## Providence Bicycle and Pedestrian Advisory Commission

**Staff Report: Capital Improvement Program Contract 1 30% Review – Mount Pleasant, Elmhurst, Wanskuck, Charles – Wards 4, 5, 12, 14 (For Action)**

*Presented at May 16, 2018 BPAC meeting*

EATON STREET  
SIGNING & STRIPING PLAN 2

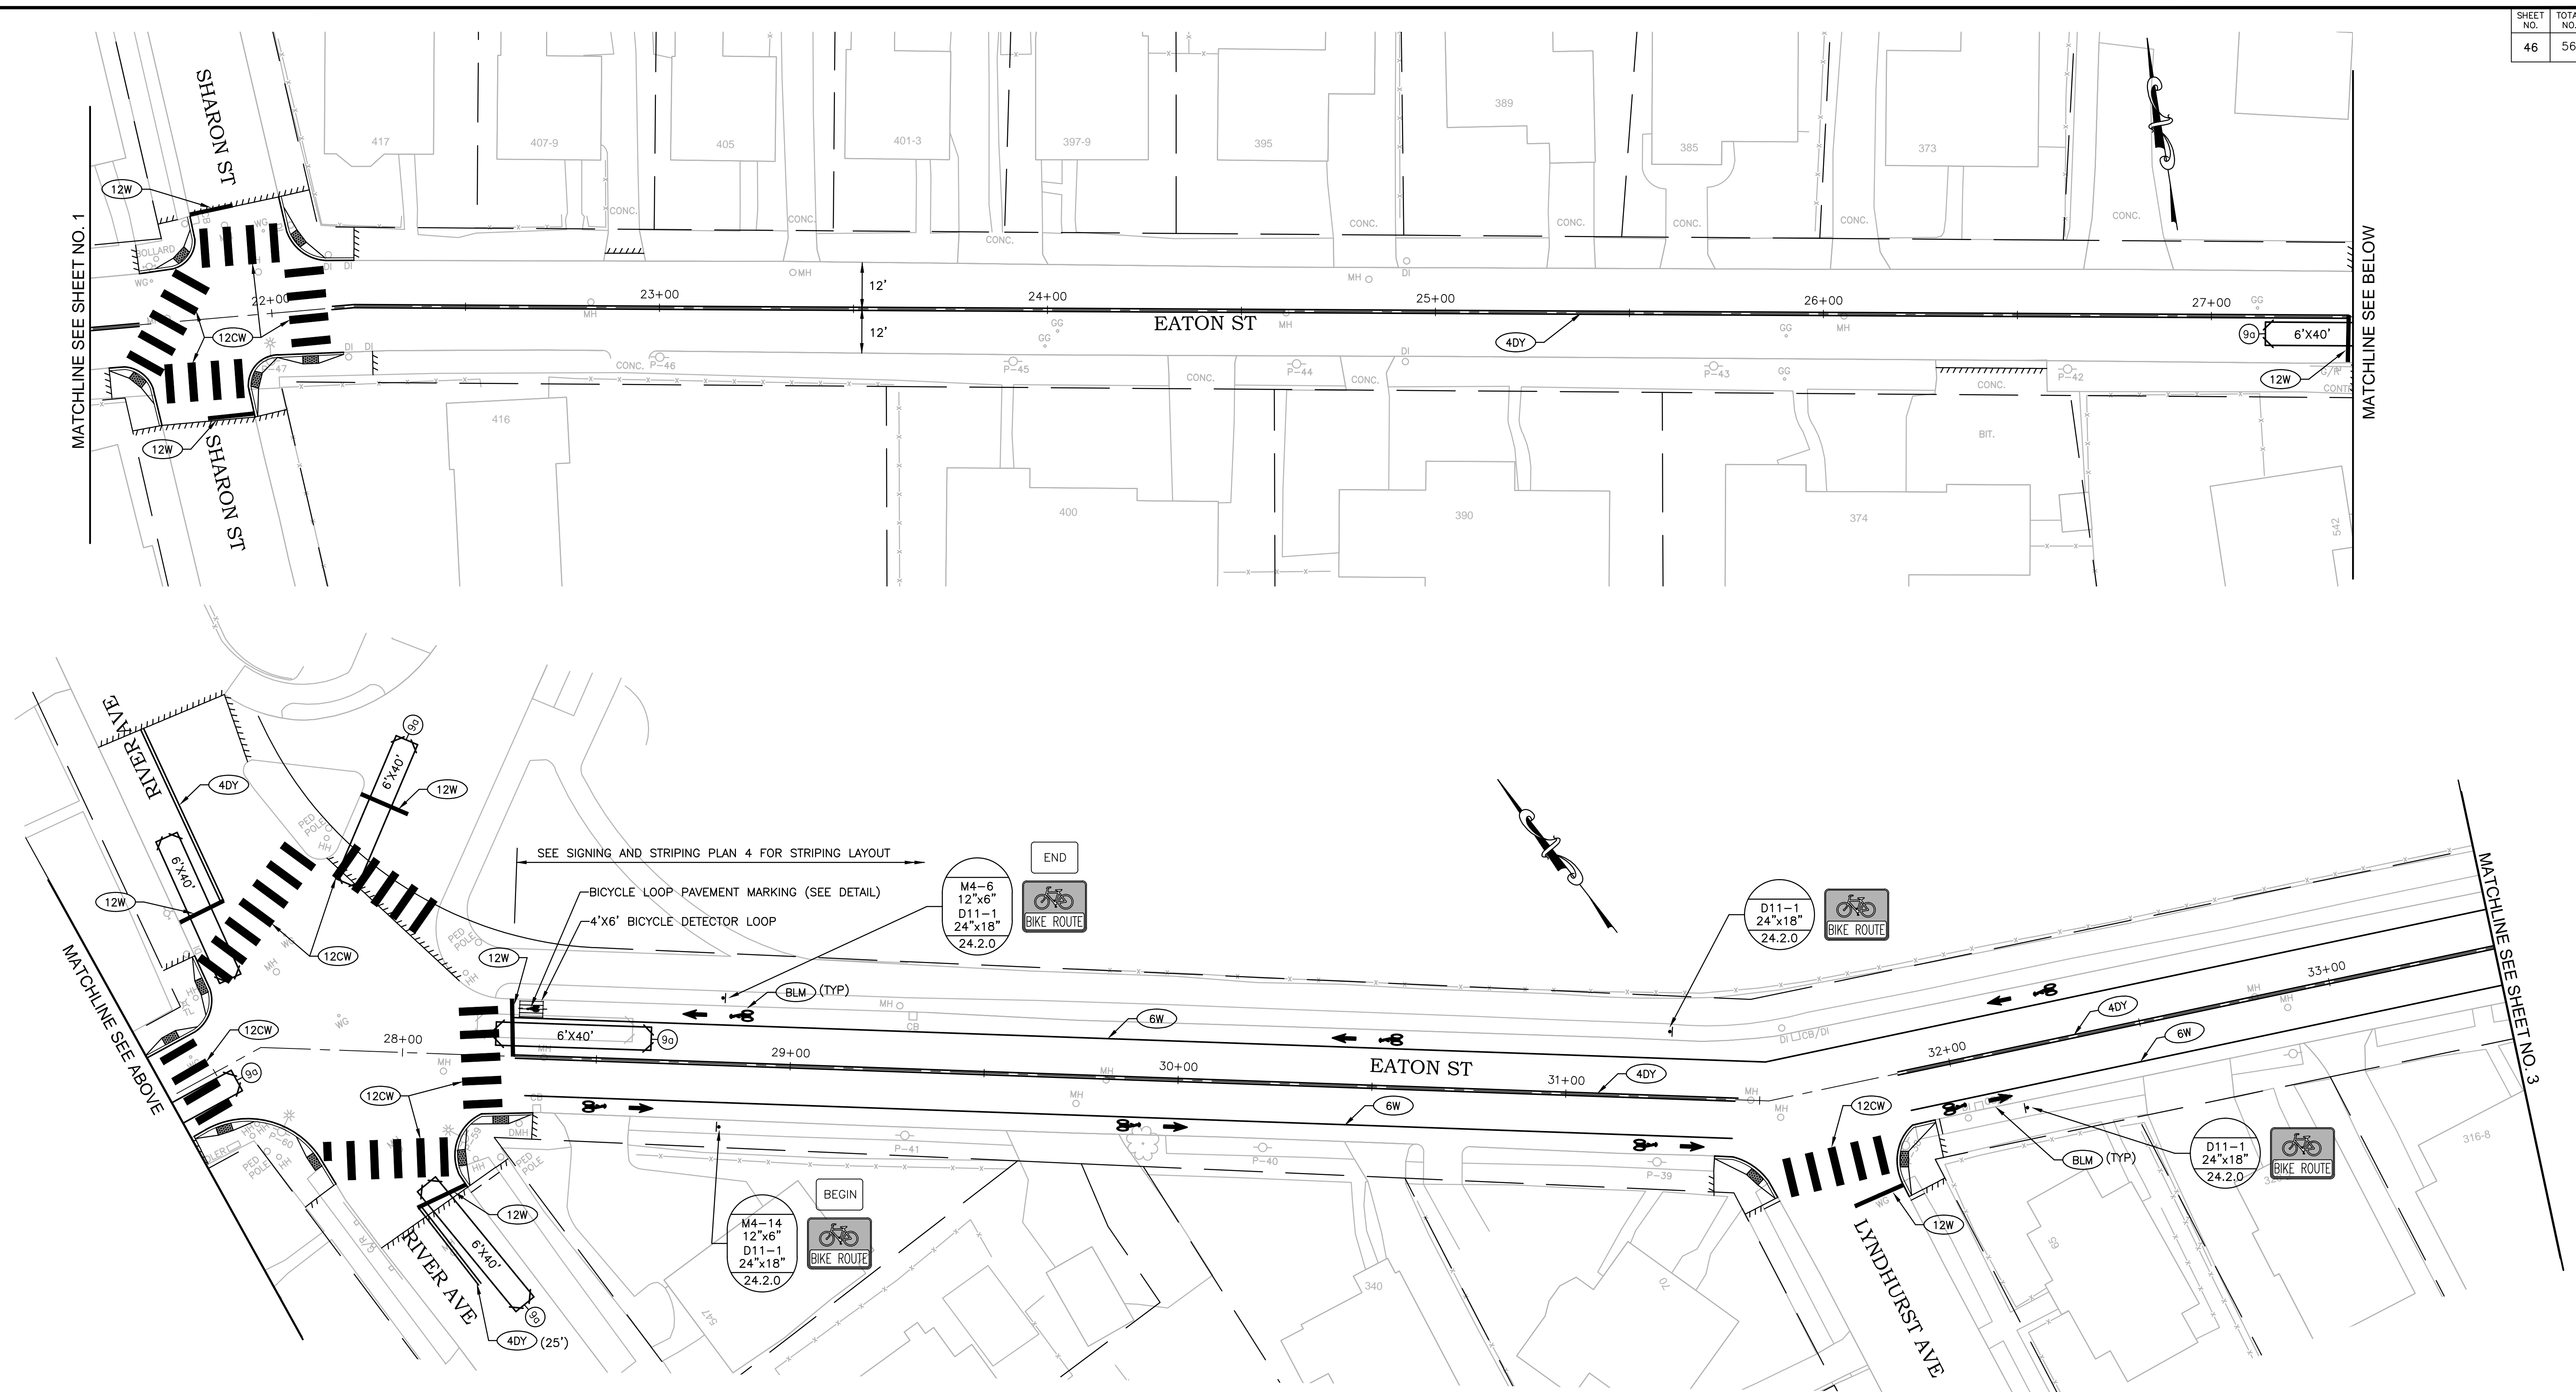
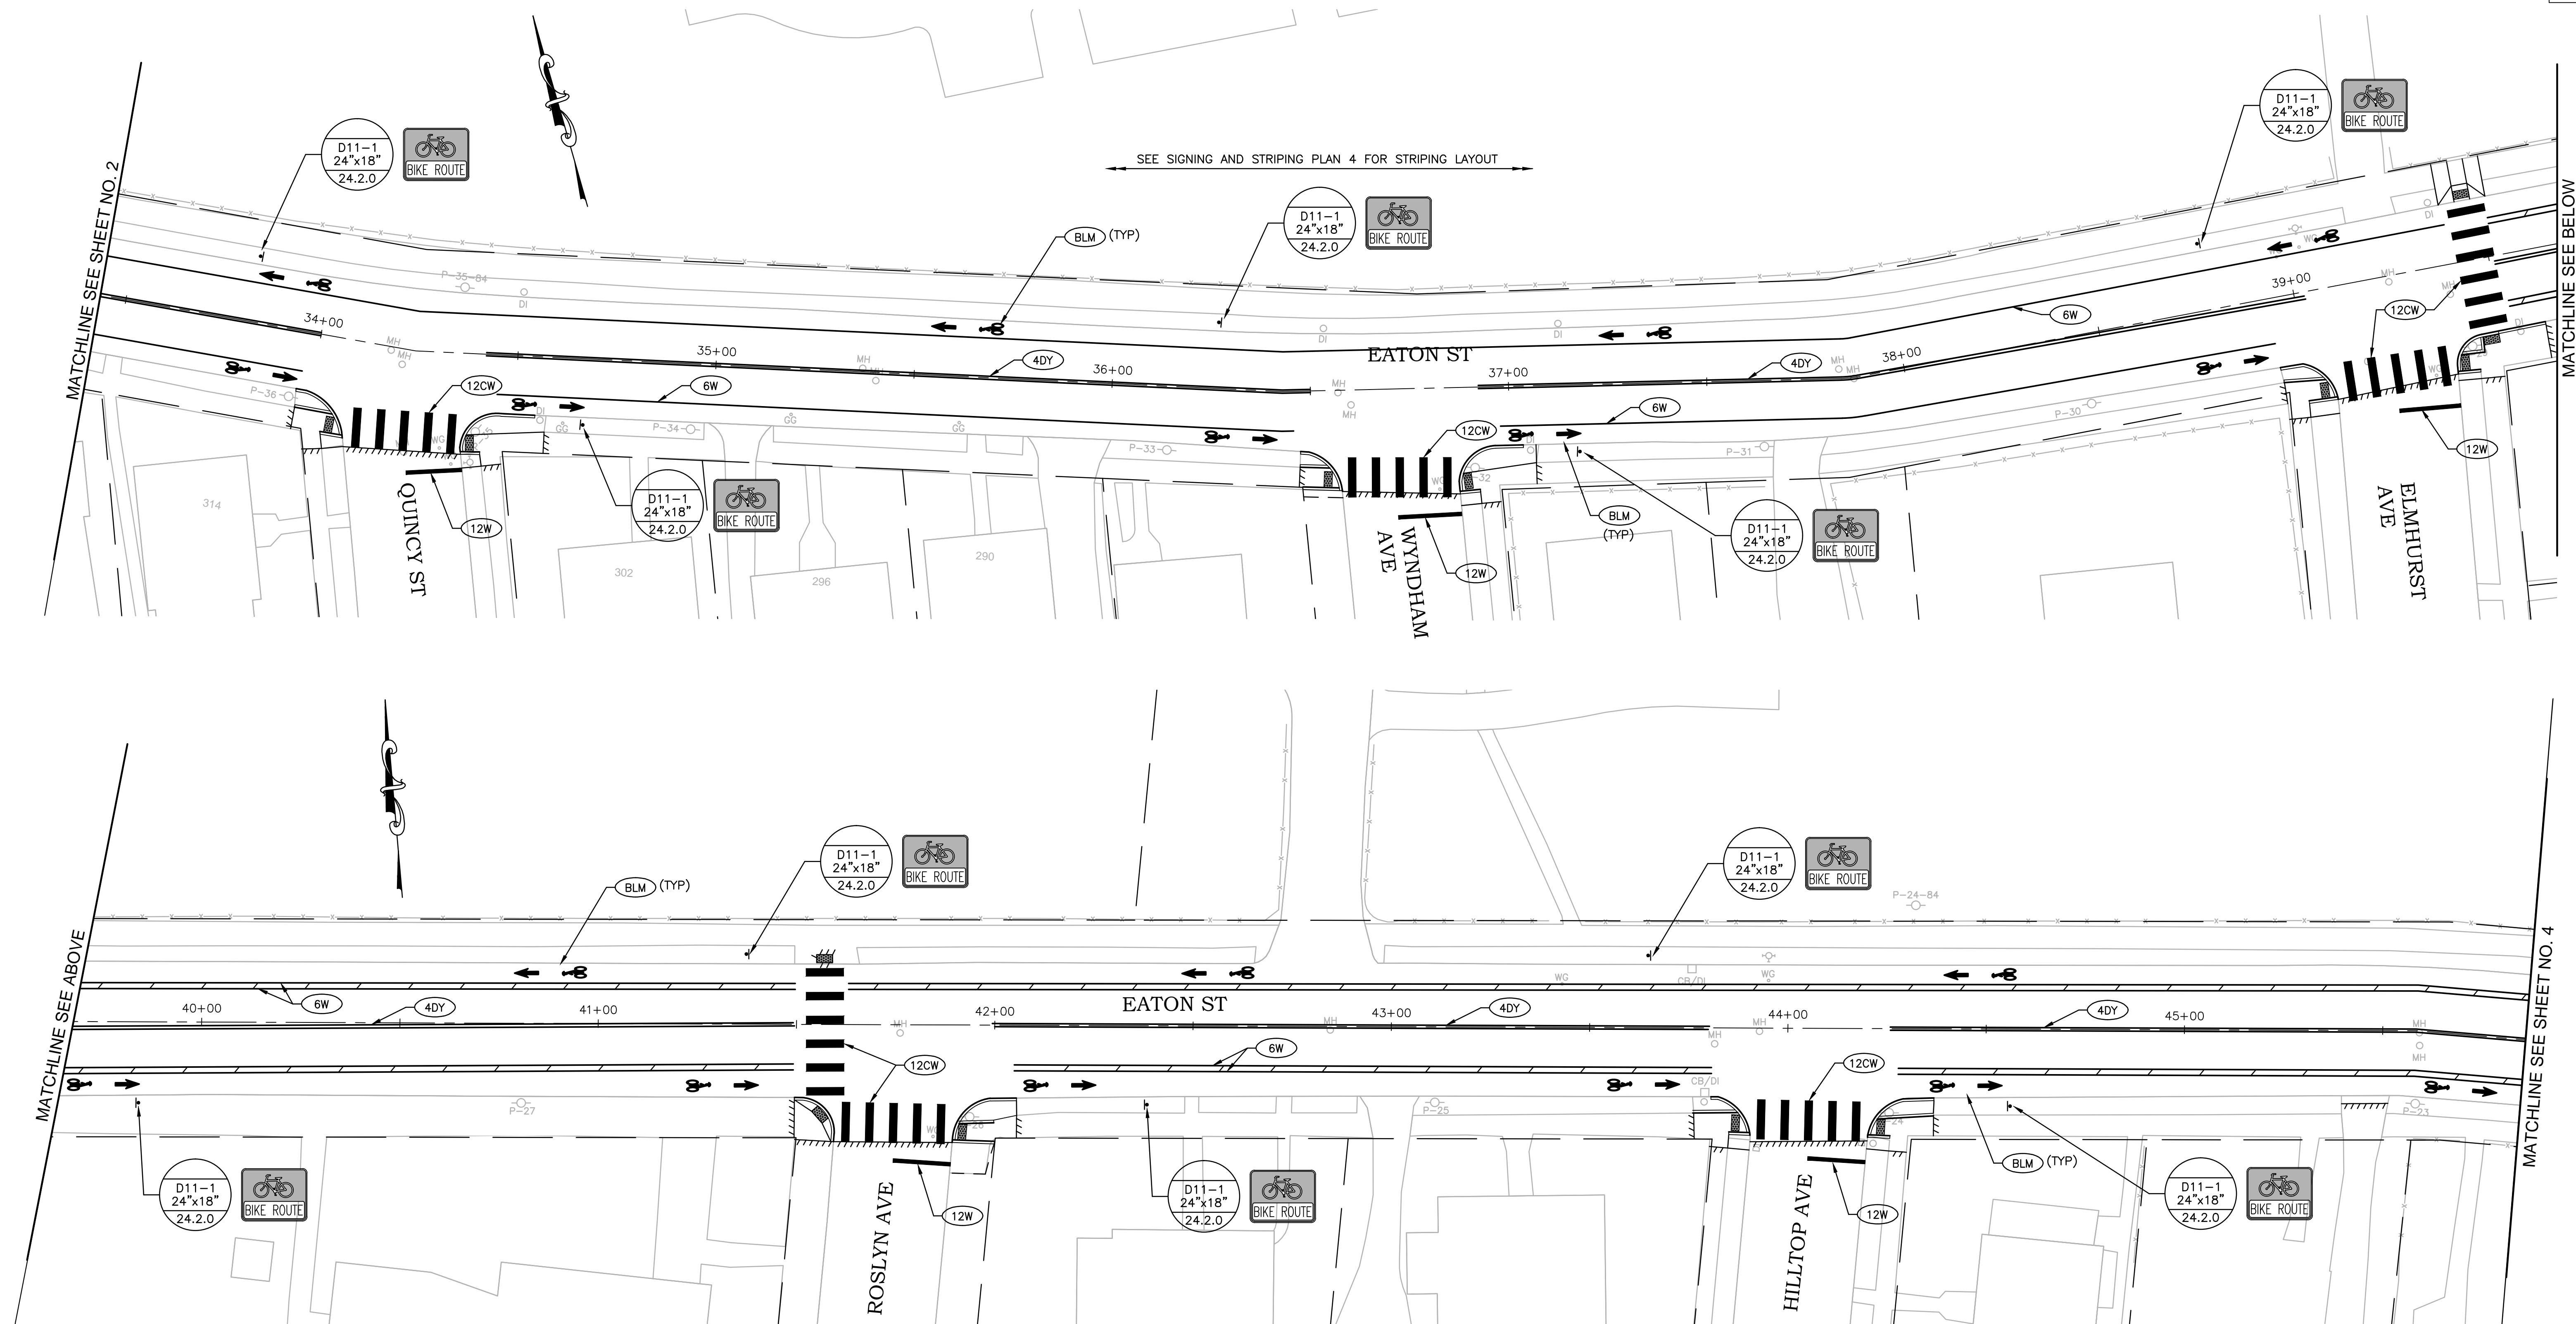
- Eaton Street
  - Eaton St between Douglas Ave and Wyndham St should be restriped to fit two 10 ft travel lanes and two 5 ft bike lanes against the curb, each separated by a 2 ft buffer.

- Between Wyndham St and River Ave, a similar configuration should be restriped, but due to the narrower width, the buffers should be omitted (5 ft bike lane, 10 ft travel lane, 10 ft travel lane, 5 ft bike lane).

- **Eaton Street is striped in the attached plans in accordance with these recommendations, but only east to the edge of the Capital Improvement Program scope at Tyndall Ave.**
